Submittal Review Response

Project Name: Hilo WWTP Rehabilitation and Replacement Project Phase 1
Submittal No.: 03200-003.0
Date: 9/25/2025

Client: County of Hawai'i **Carollo Project No.:** 203975
Contractor: Nan, Inc.
Submittal Name: Concrete Reinforcing Screening Wall and Top Slab
Reviewed By: Marissa Kurniawan, Hipom Caleb Che

SCREENING TOP SLAB REINFORCEMENT LAYOUT

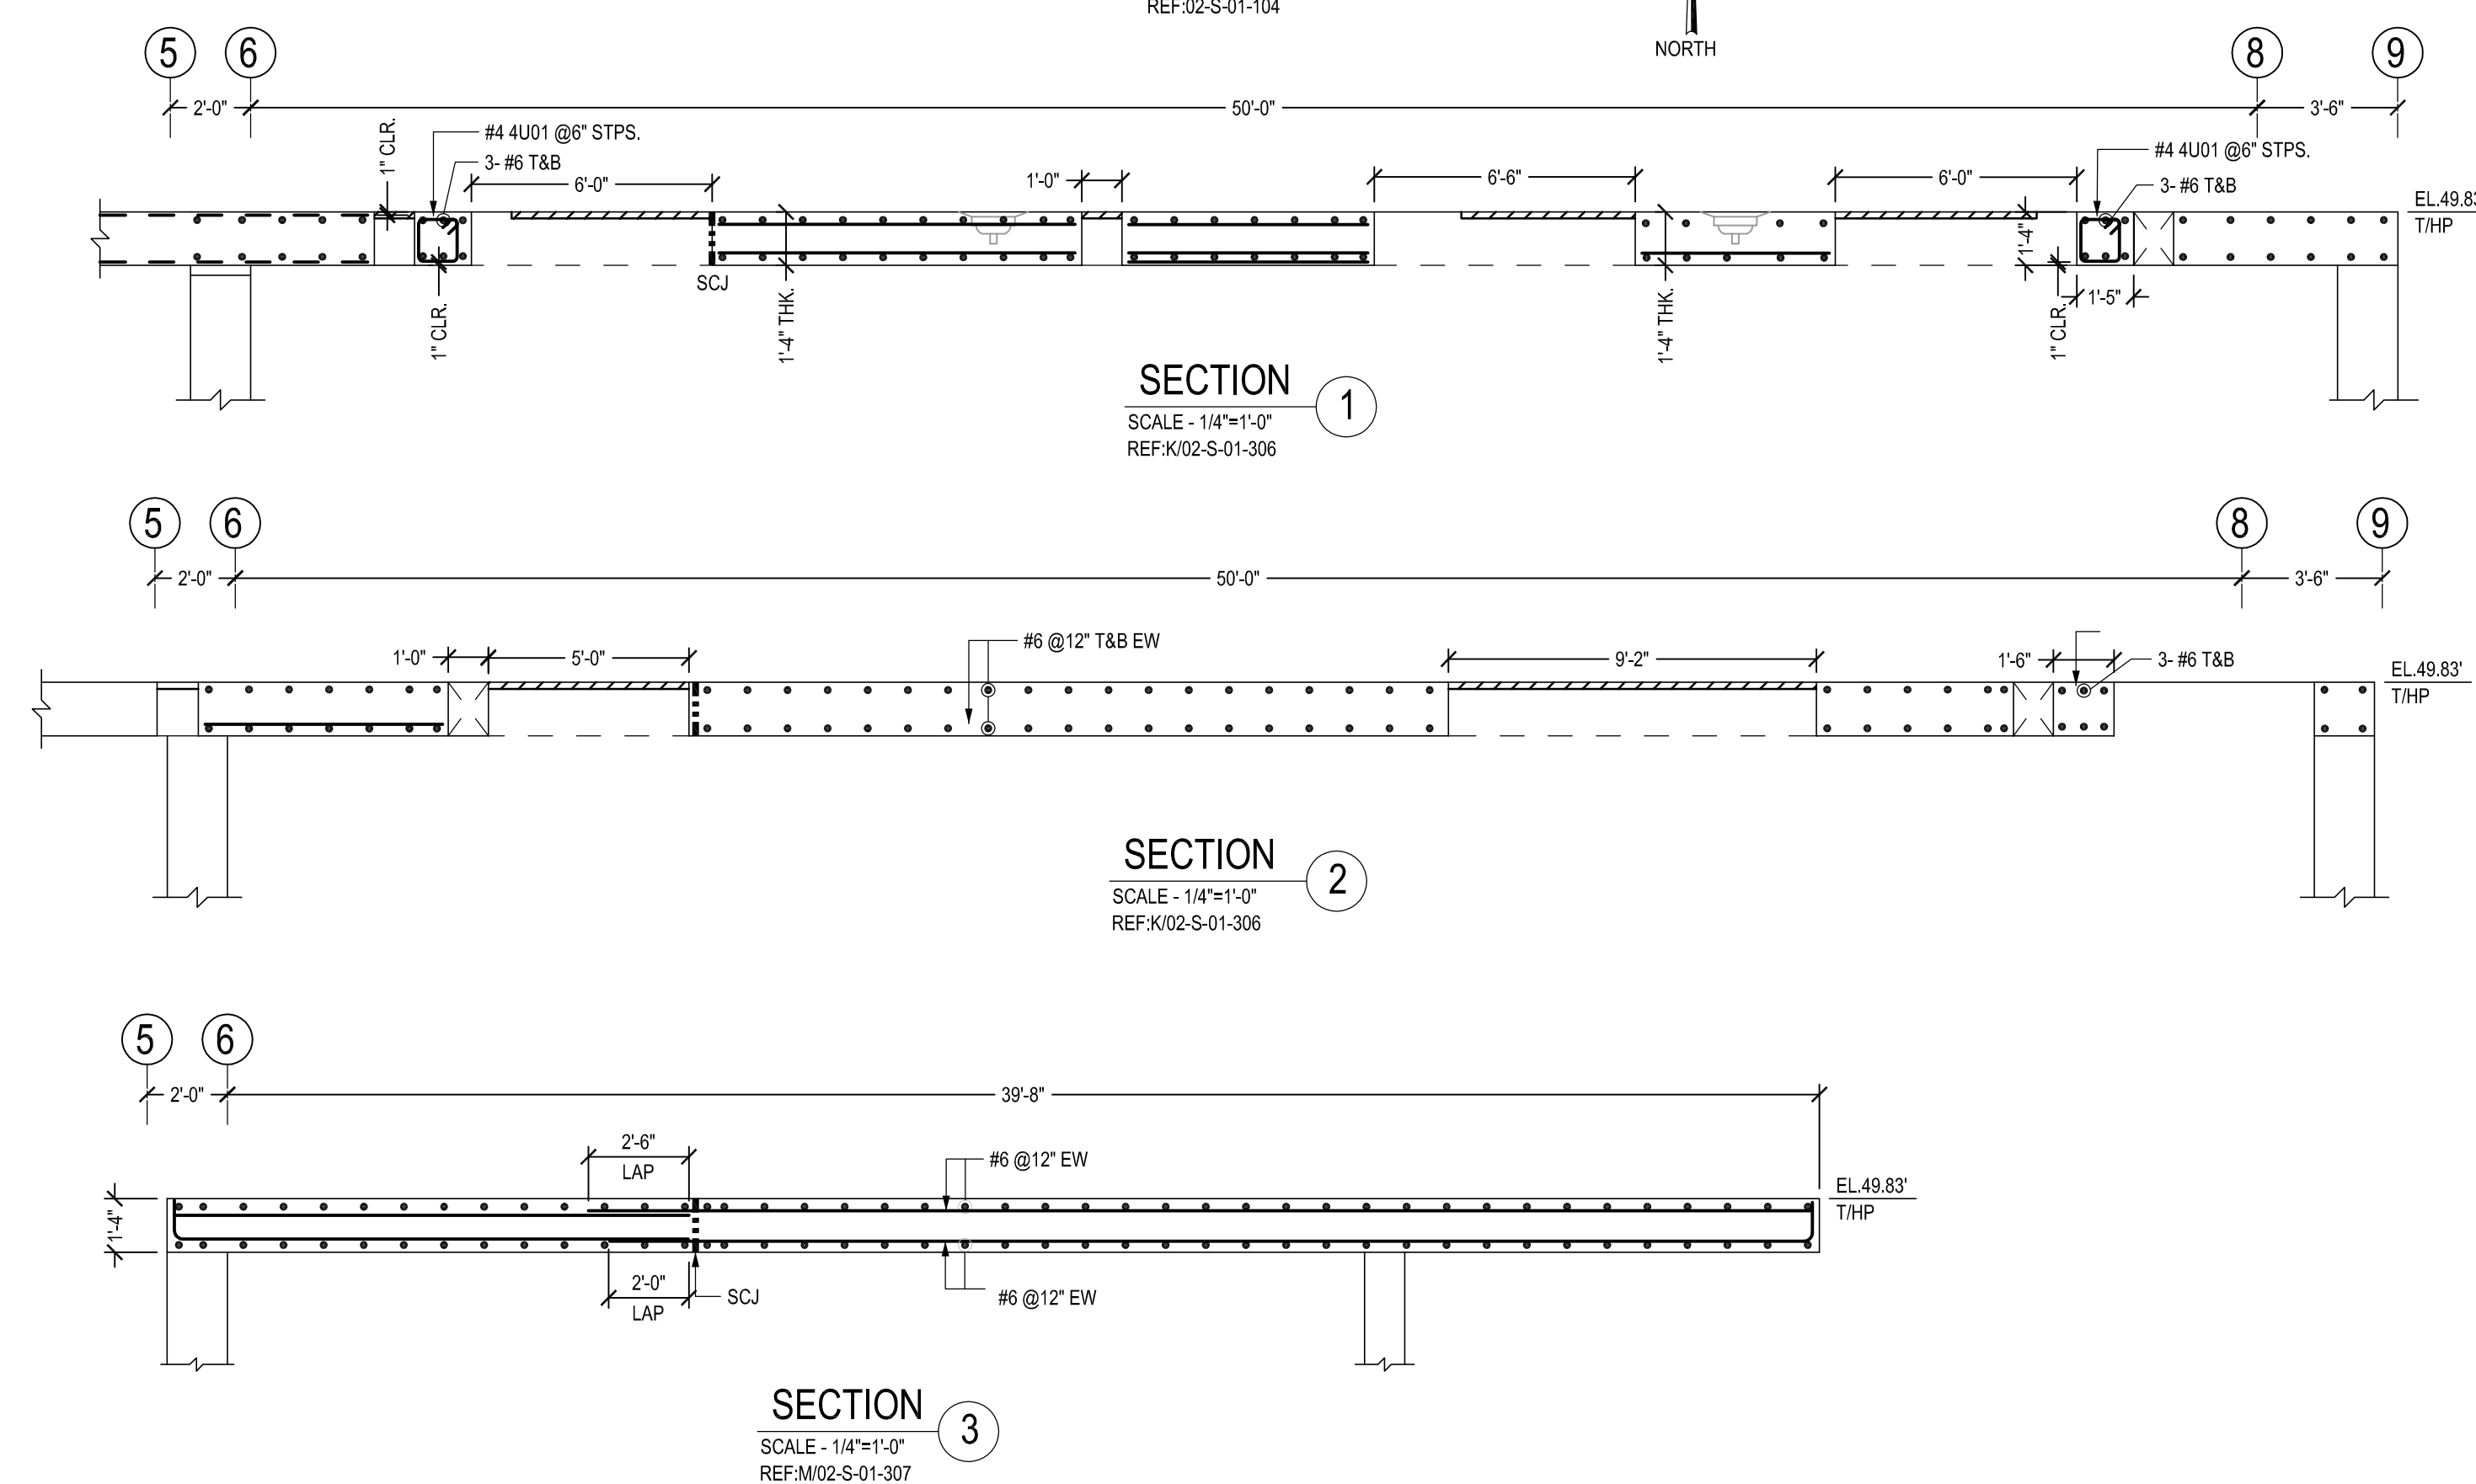
- The reinforcement detailing between slab openings on the screening top slab plan view is unclear (clouded areas on submittal page 3 and 4). Revise to clearly show 3 #6 bars top & bottom total for each clouded area on plan shop drawings per contract drawing 02-S-01-104, keynote 9 and detail 10/02-S-01-501.

- Screening top slab reinforcement plan view drawings show horizontal reinforcement spanning long way and short way going through small openings. Verify and coordinate reinforcement arrangement in areas with these openings and revise shop drawings as necessary.
